**BEFORE THE BOARD OF PATENT APPEALS
AND INTERFERENCES**

Application Number: 10/671,086
Filing Date: September 25, 2003
Appellant(s): ALVORD ET AL.

EXAMINER'S ANSWER

A. The instant application is directed towards and/or related to the field of target assemblies for use with accelerators for the production of radioisotopes. More particularly to a target assembly, i.e. an apparatus, for containing a fluid for irradiating Oxygen-18 with protons in order to create Fluorine-18.

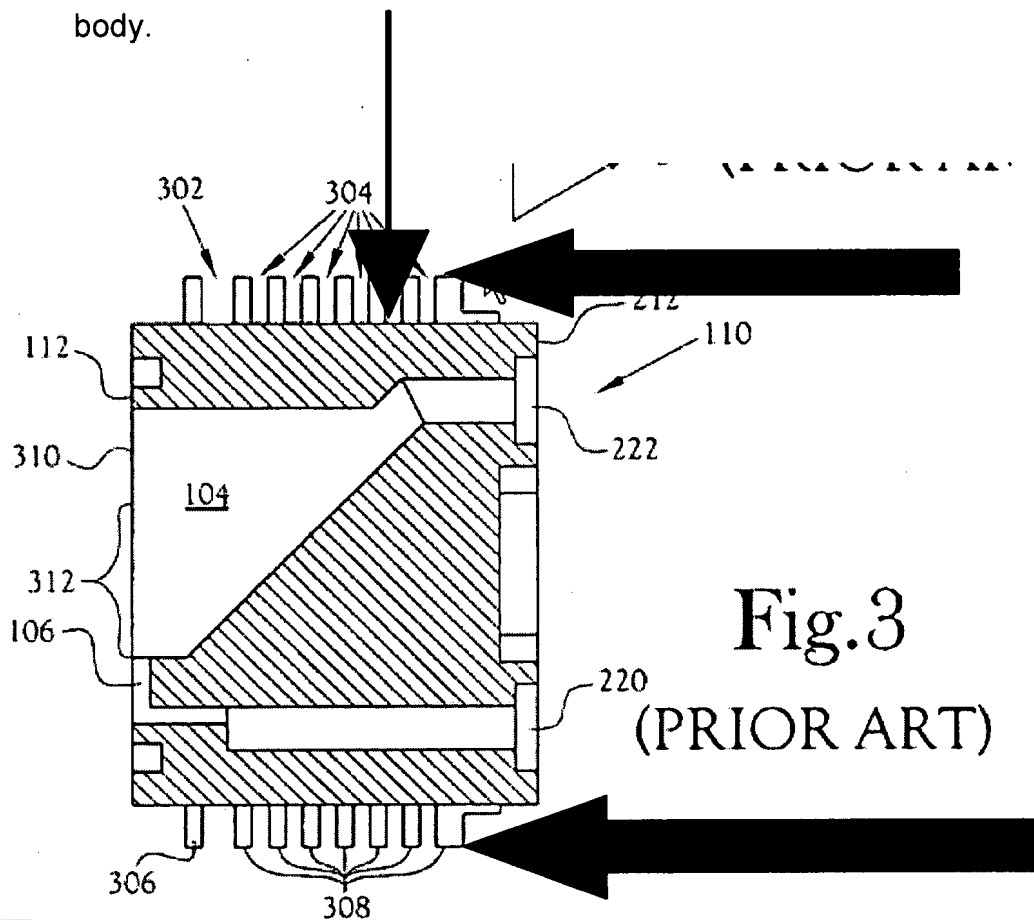
3.) Further, resort may be had to case law wherein it is OBVIOUS to integrate the cooling channels to the inside of the target body and it is further OBVIOUS to duplicate the cooling channels as such is nothing more than a duplication of parts performing the SAME FUNCTION, i.e. cooling.

See, for examples, In re Wolfe, 116 USPQ 443, 444 (CCPA 1961)), In re Larson, 340 F.2d 965, 968, 144 USPQ 347, 349 (CCPA 1965), In re Harza, 124 USPQ 378 (CCPA 1960) "Mere duplication of parts has no patentable significance unless new and unexpected result is produced"

In this case, only additional cooling would be the result, which IS NOT UNEXPECTED.

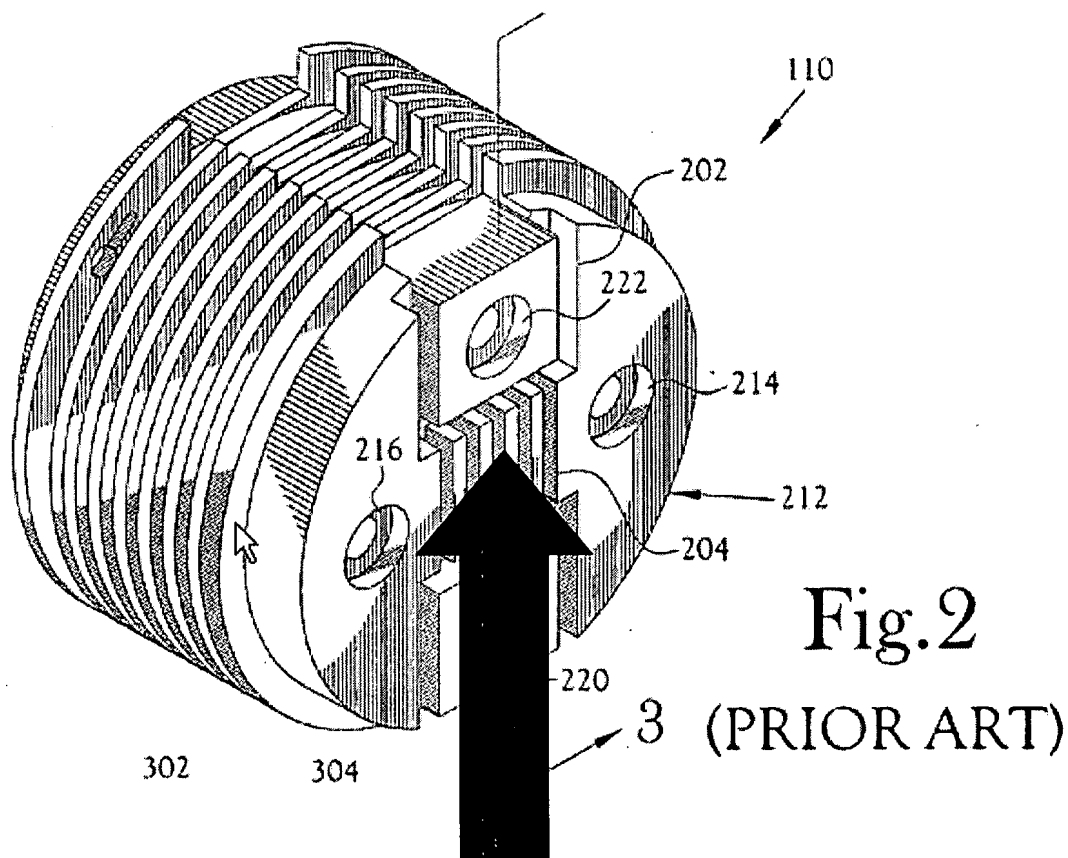
2.) Appellant further argues that the APA target assembly does not contain a cooling channel running along at least a portion of a sloped rear wall of a target chamber as claimed. This limitation can be read in multiple ways:

First, channels 302, 304 are within the circumference of the target body, accordingly the vertical arrow in Fig 3 above indicates a portion of the cooling channel running along a portion of the sloped rear wall.

Second the back of the target also has cooling channels that run alongside a portion of the sloped rear wall as shown in Fig. 2 below.

Again, the cooling channels of the prior art run along at least a portion of the rear wall just as two lanes of a divided highway run along each other, since Appellant has failed to set forth the metes and bounds of the limitations "running along at least a portion of said rear wall" the examiner has given the limitation the broadest reasonable interpretation.
